## REVISED RESPONSE TO REQUEST FOR ADDITIONAL INFORMATION

### APR1400 Design Certification

RAI No.: 129-8085  
SRP Section: 03.08.01 – Concrete Containment  
Application Section: 03.08.01  
Date of RAI Issue: 08/05/2015

### **Question No. 03.08.01-5**

Figure 5-4 Containment Pressure for Loss of RHR (Mode 5)

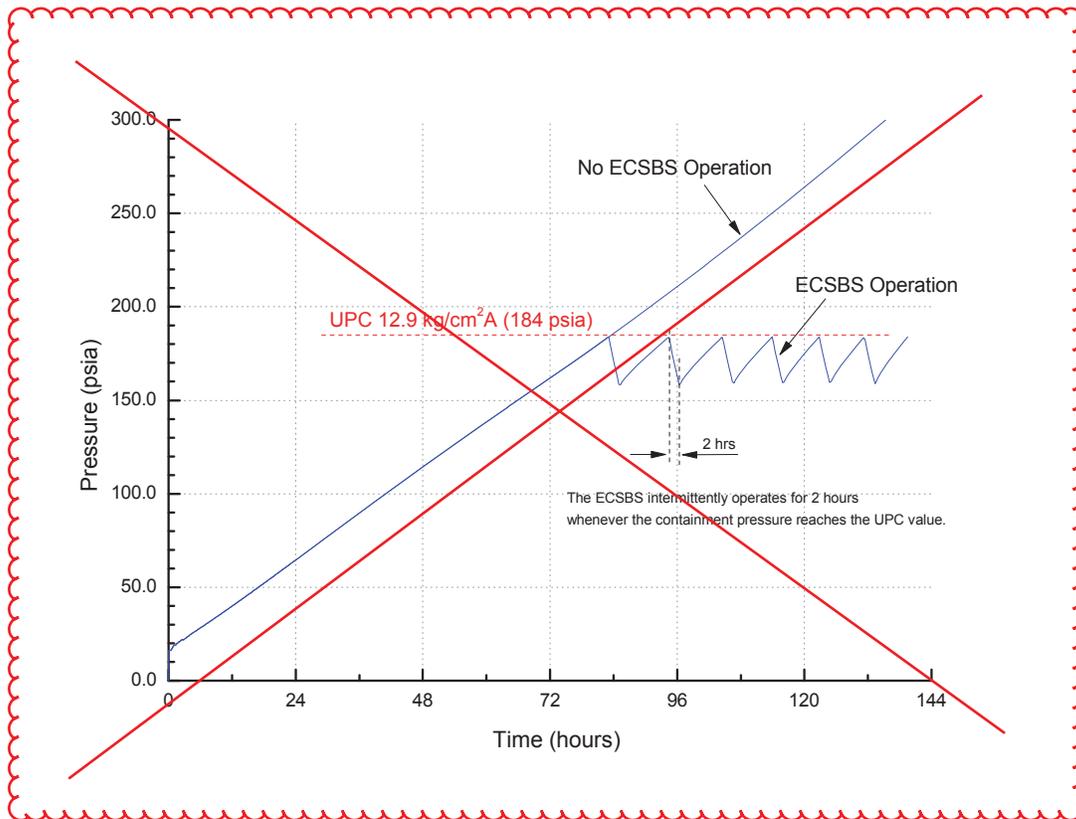
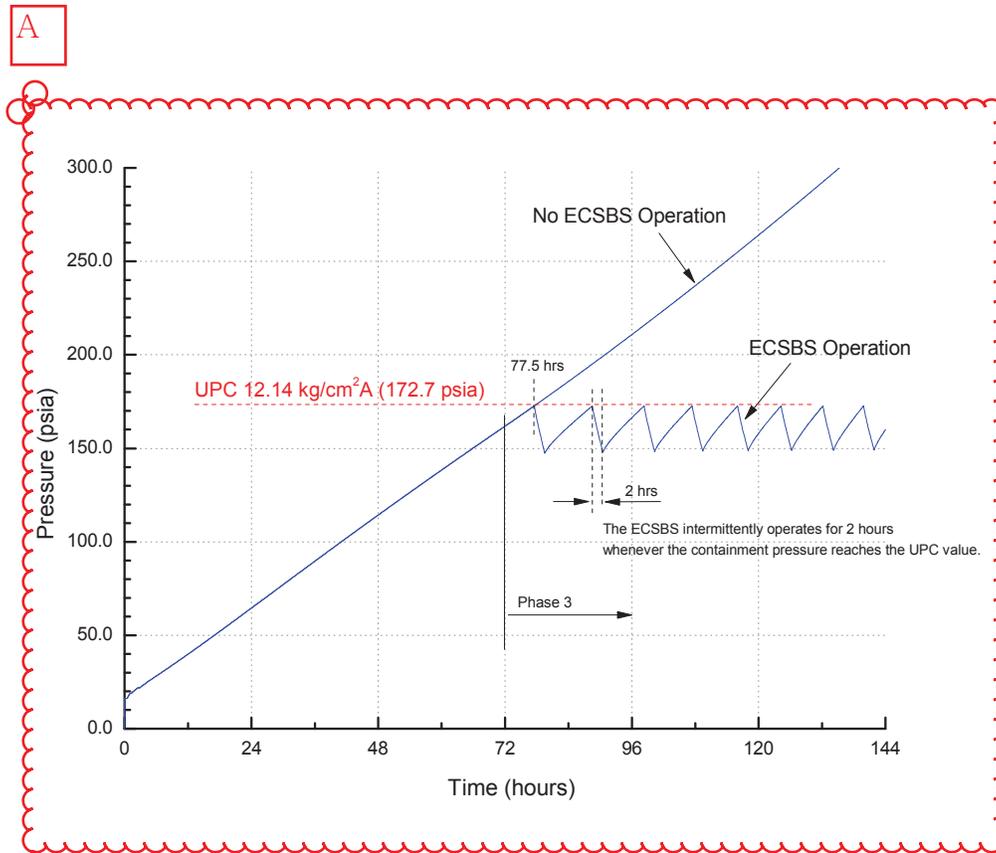
GOTHIC analyses are performed for evaluation of the containment pressure and temperature responses following loss of RHR in mode 5. Figure 5-4 shows that the containment pressure reaches the UPC value in about ~~3.5 days~~ without ECSBS operation, but with the intermittent operation of ECSBS, containment pressure can be maintained within the UPC limit. Figure 5-5 shows that the containment temperature is maintained well below 185 °C (365 °F), which is less than the upper limit temperature of 196 °C (385 °F) for ensuring the operability of RCS sensors.

Replaced with next page, A

11.11 kg/cm<sup>2</sup> (158 psi)

77 hours

Figure 5-5 Containment Temperature for Loss of RHR (Mode 5)

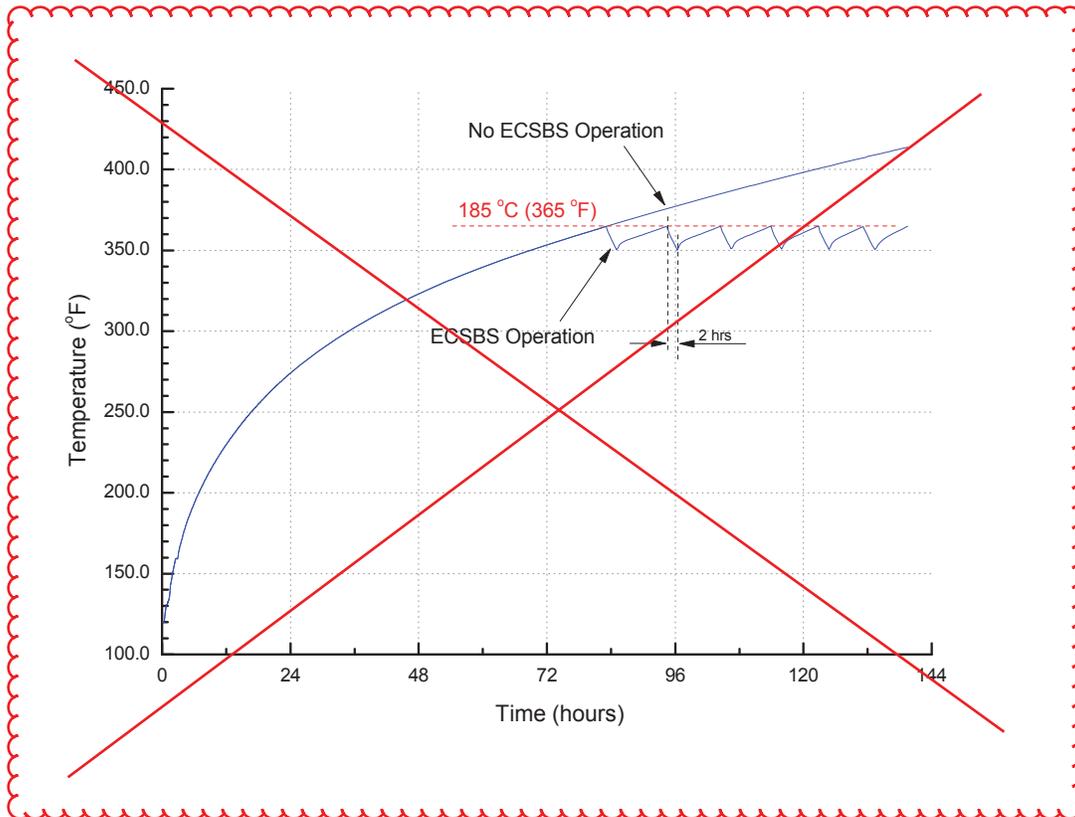
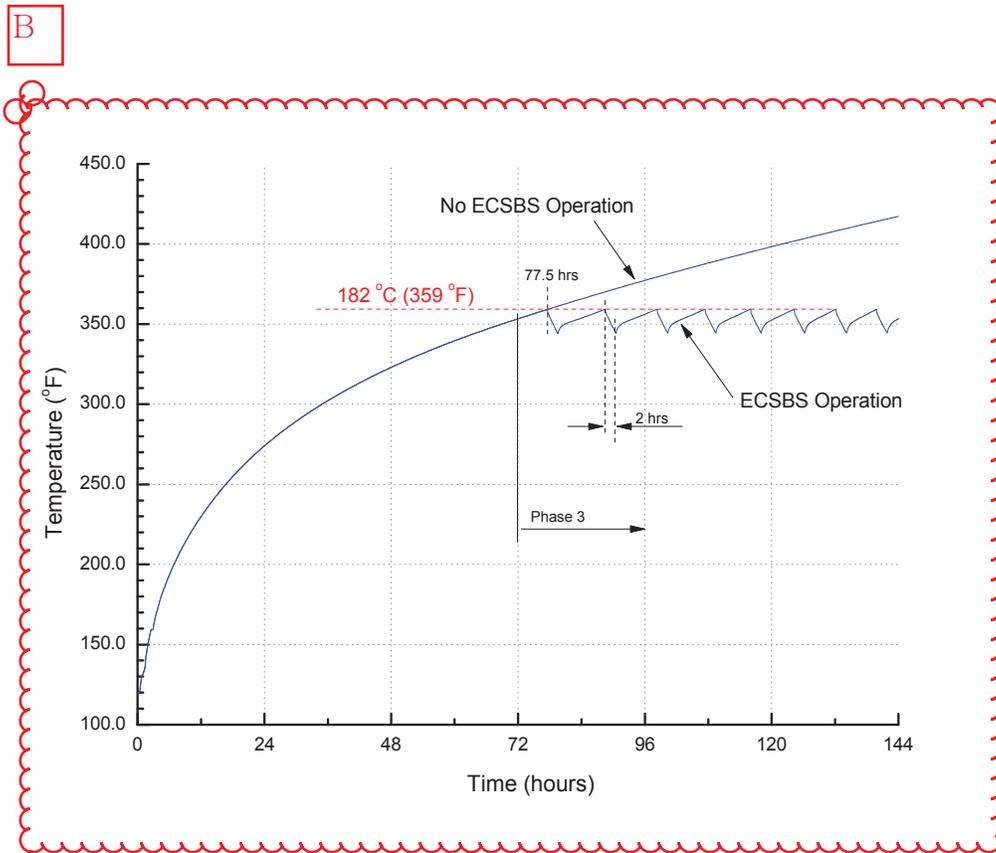
Replaced with next page, B

182 °C (359 °F)
